Addendum #5

CASWELL CENTER

BOILER INSTALLATION AT KENDALL & JOHNSON HALL

SCO ID #: 22-25054-01A Code: 42140 Item: 4S10 | Sigma Project # 22057

**Mechanical Partial
Site Plan**

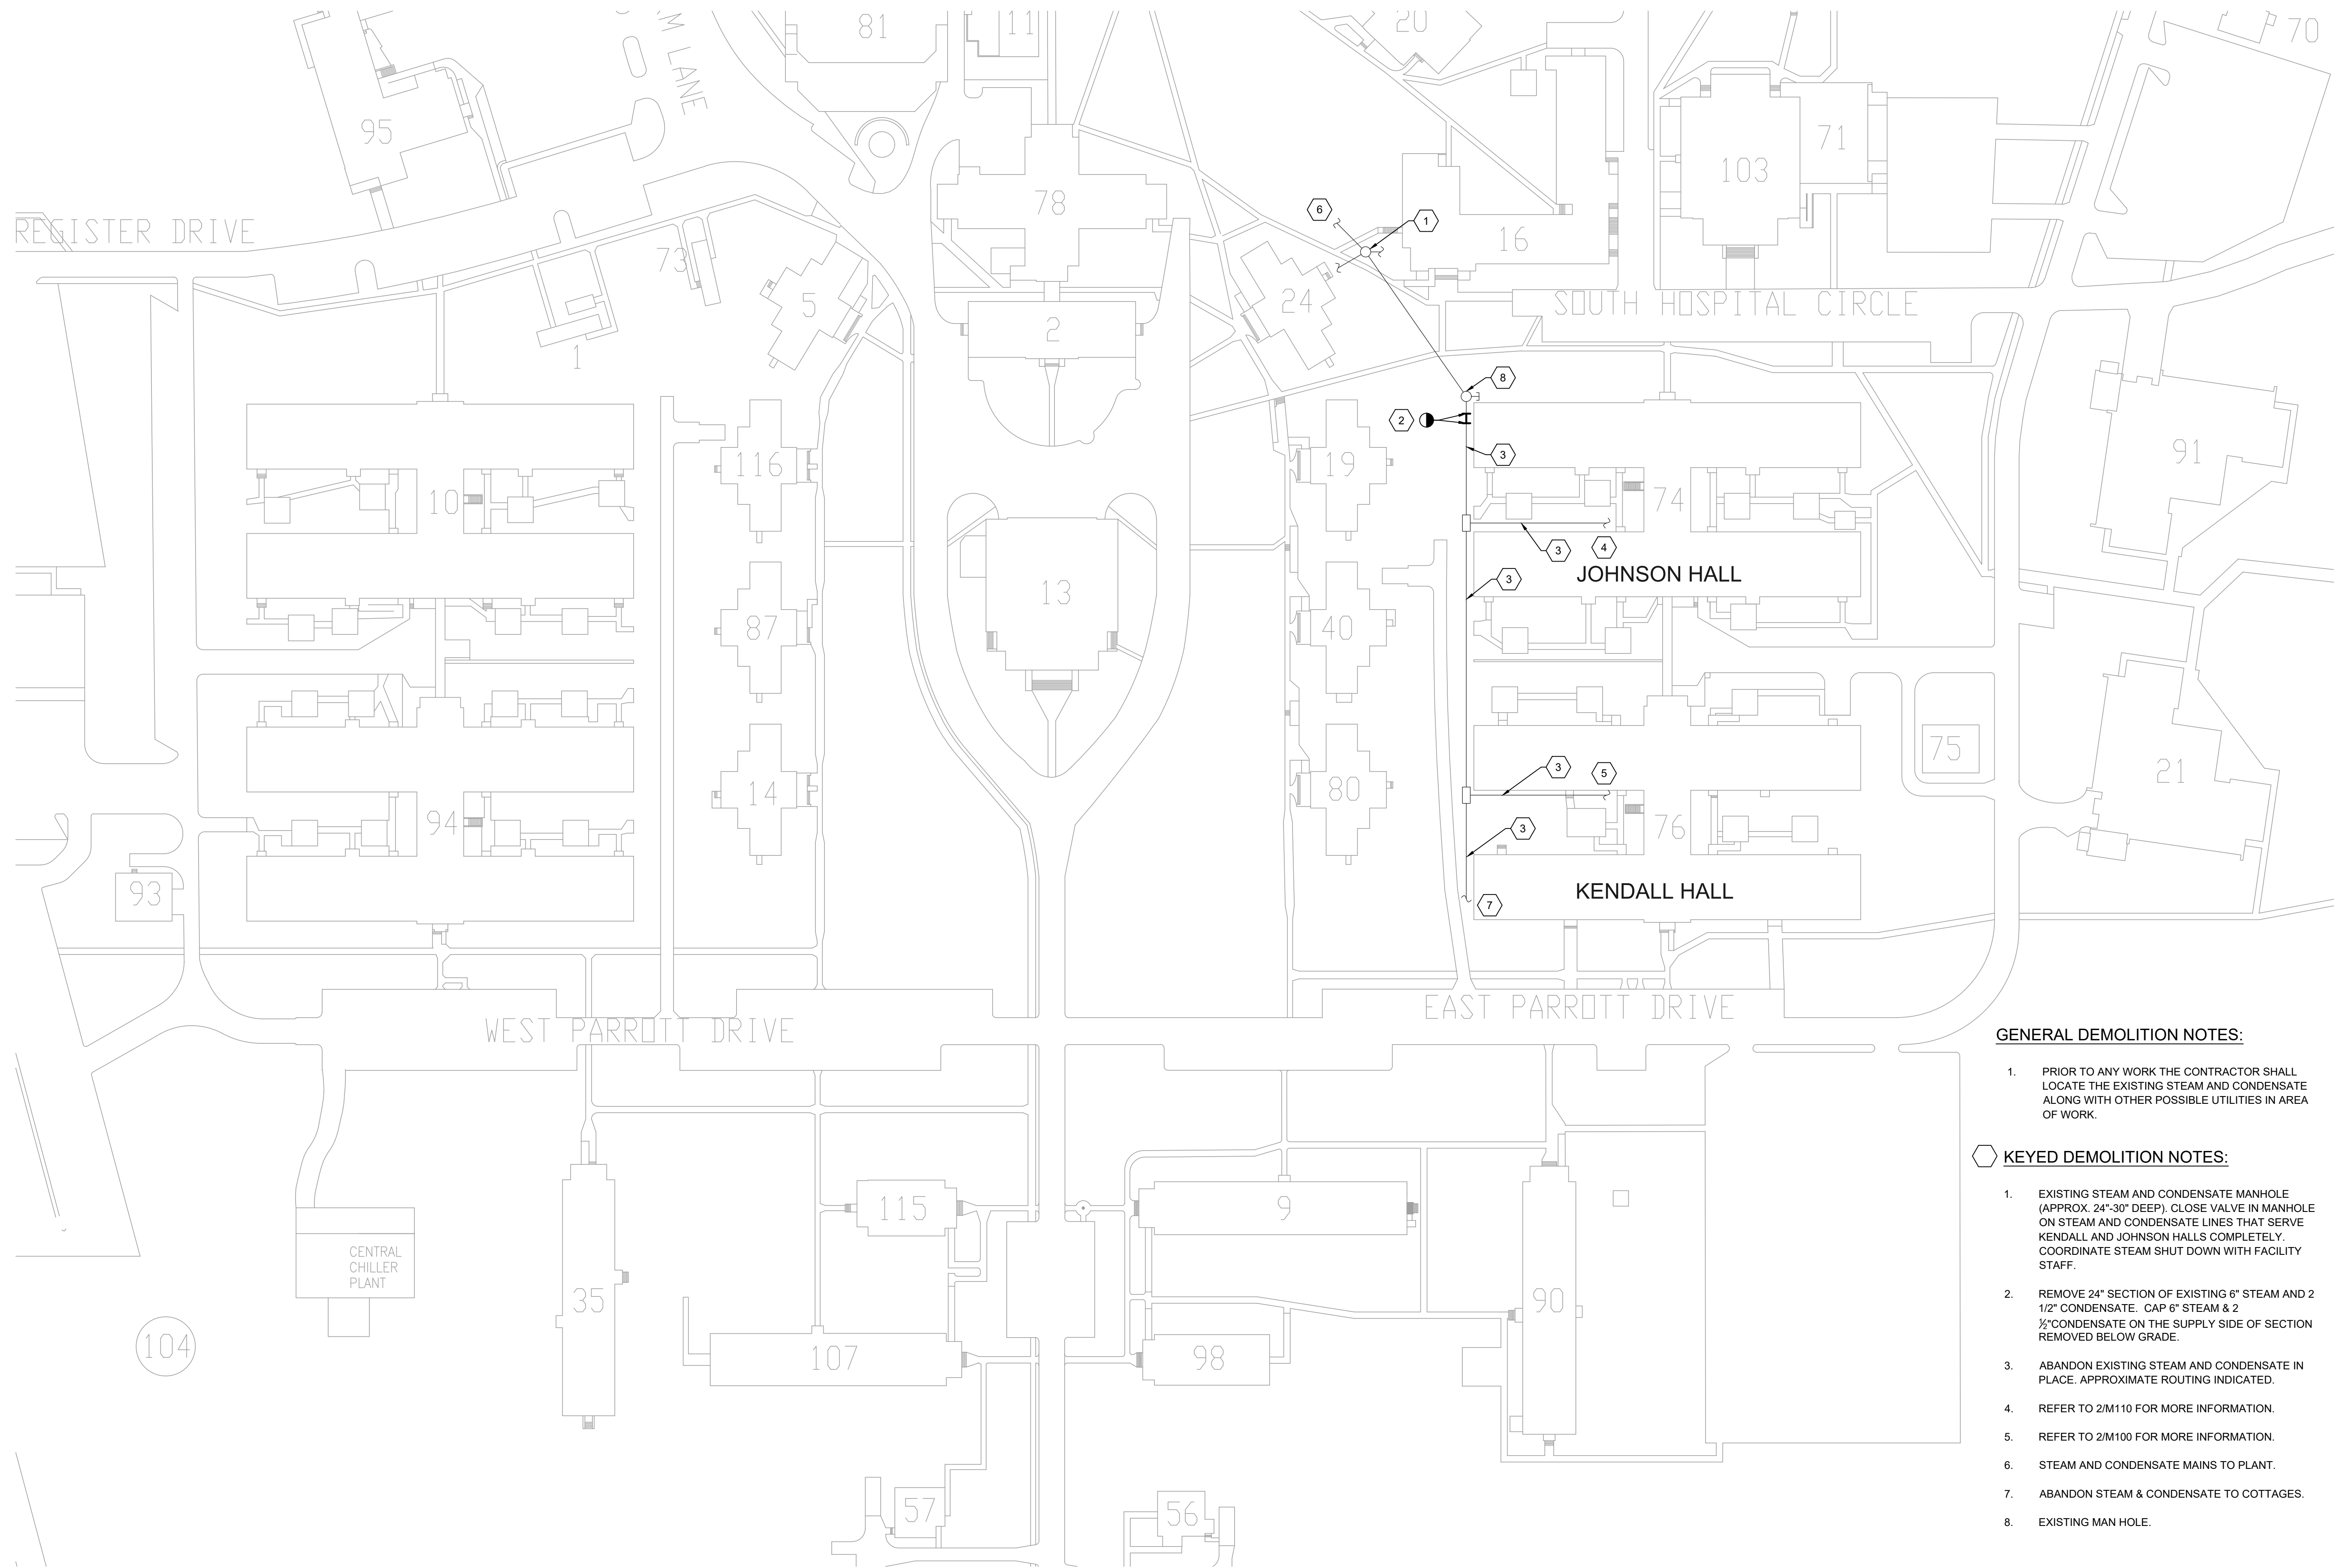
- a) Sheet M003: This sheet is being added. It is a mechanical partial site plan to indicate the new disconnection point from existing steam and condensate.
- b) Sheet M100: This sheet was revised and is being reissued.
- c) Sheet M110: This sheet was revised and is being reissued.
- d) Sheet M200: Detail 1/M200 scale shall read 1/16"=1'.
- e) Sheet M210: Detail 1/M210 scale shall read 1/16"=1'.
- f) Sheet E100: Detail 1/E100 scale shall read 1/16"=1'.
